DATE OF MEETING | August 13, 2018 |

AUTHORED BY | TAMERA ROGERS, PLANNER, CURRENT PLANNING AND  
SUBDIVISION |

SUBJECT | **DEVELOPMENT PERMIT APPLICATION NO. DP1032 –  
119 HALIBURTON STREET** |

To present for Council's consideration, a development permit application for a five-storey, 36-unit condominium development with underground parking. |

ATTACHMENT D  
PARKING PLAN

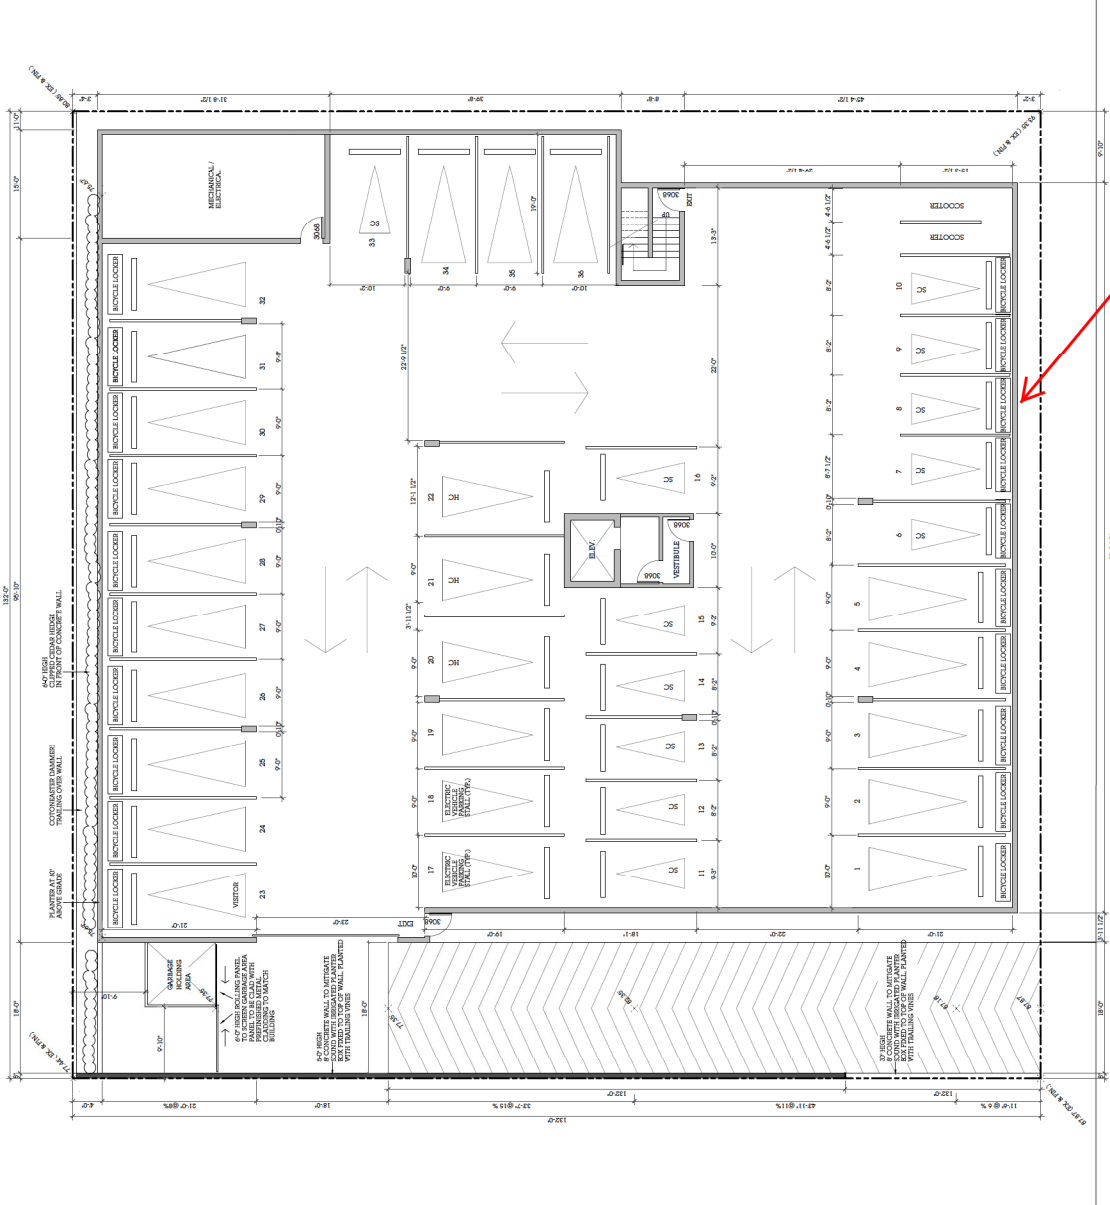
The minimum required front yard setback for an underground parking structure is 1.8m. The proposed front yard setback is 0.97m, a proposed variance of 0.83m.

Proposed Variance to Reduce Front  
Yard Setback to Underground Parkade

The underground parking structure will not be visible from the street. Maximizing the area of the underground parking structure gives priority to pedestrians and outdoor living space at grade. Staff support the proposed variance.

119 Haliburton Nanaimo, BC  
Landscape / East Elevation  
1/4" = 1'-0"

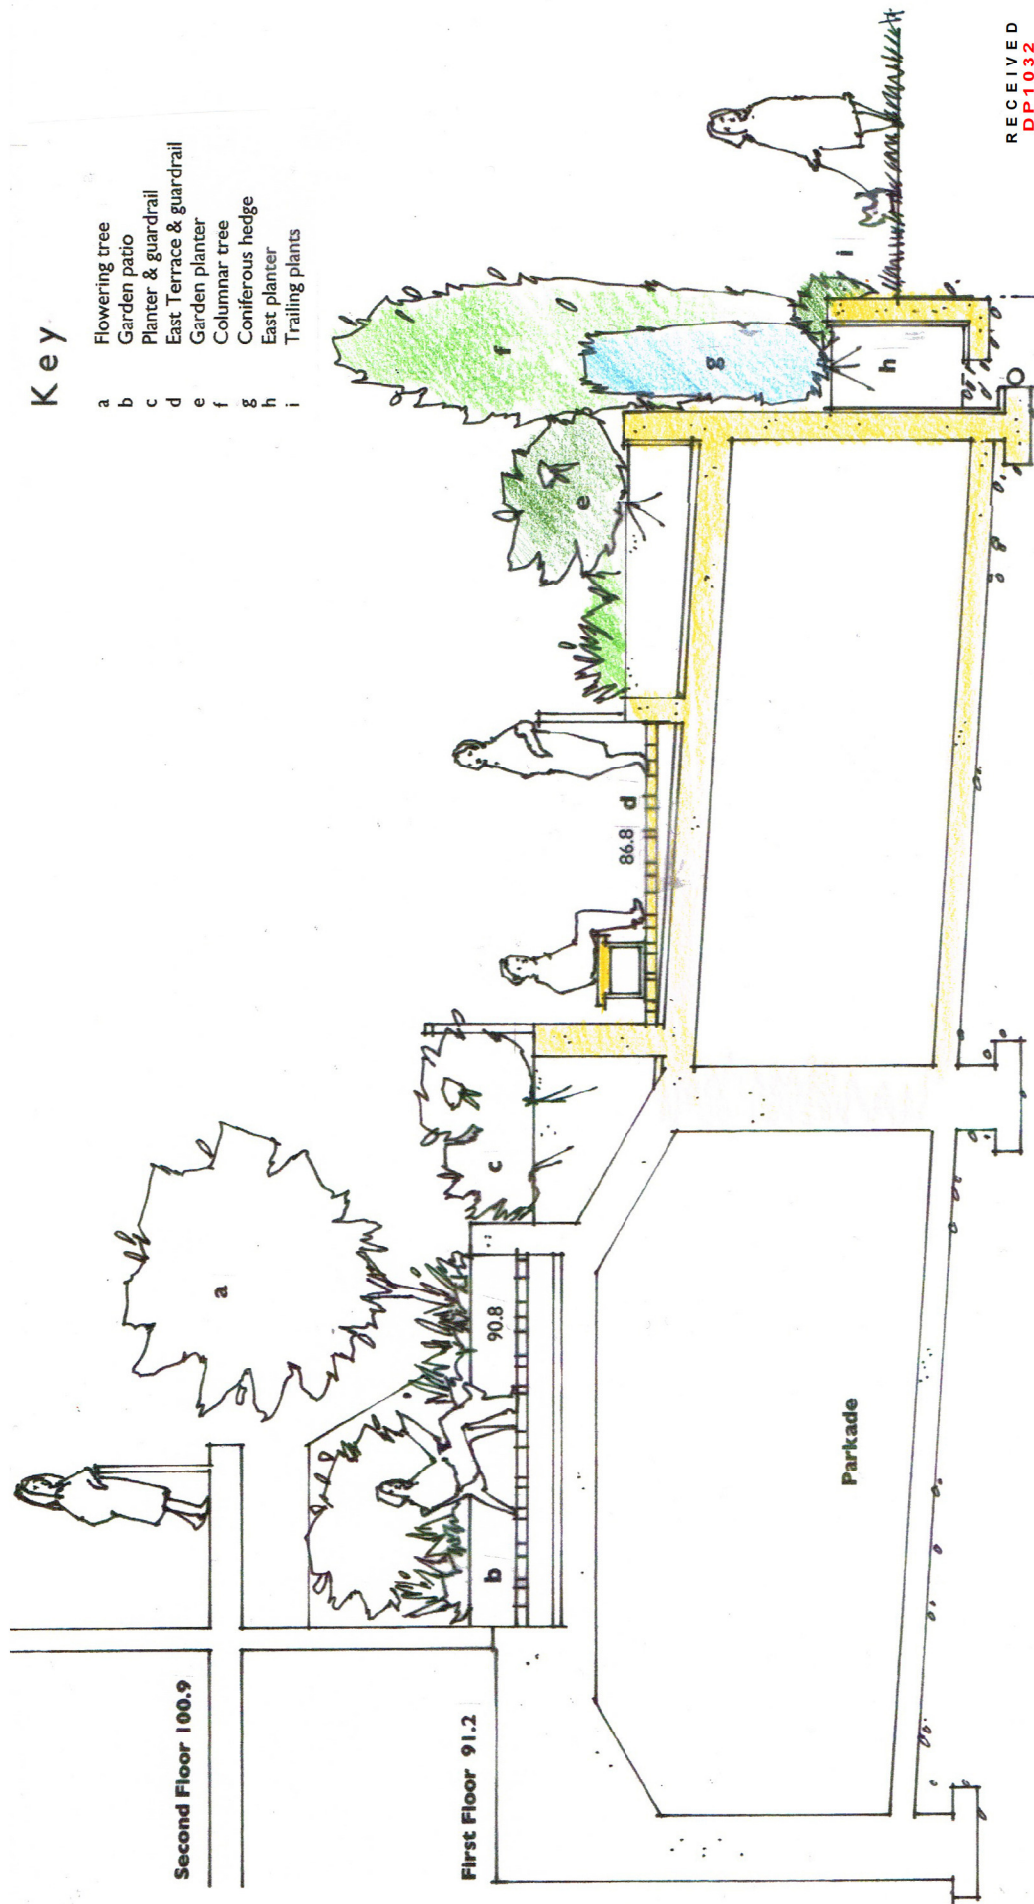
- Look at methods to mitigate vehicle noise from ramp to underground parking.
- Consider adding electric vehicle charging stalls.
- Look at methods to screen garbage enclosure.
- Look at methods to emphasize entrance walkway.
- Look at methods to better screen east-facing concrete wall.

Hedge plantings and trailing evergreen groundcover will form an adequate landscape buffer width to screen the parkade wall from the neighbours to the east. Staff support the proposed variances.

- Emphasized the front entrance with brick bollards, lighting and an extended front canopy; and
- Introduced a 2.5m-high planter on the east property line to be planted with a hedge and trailing evergreen ground cover to help screen the parkade wall from view.
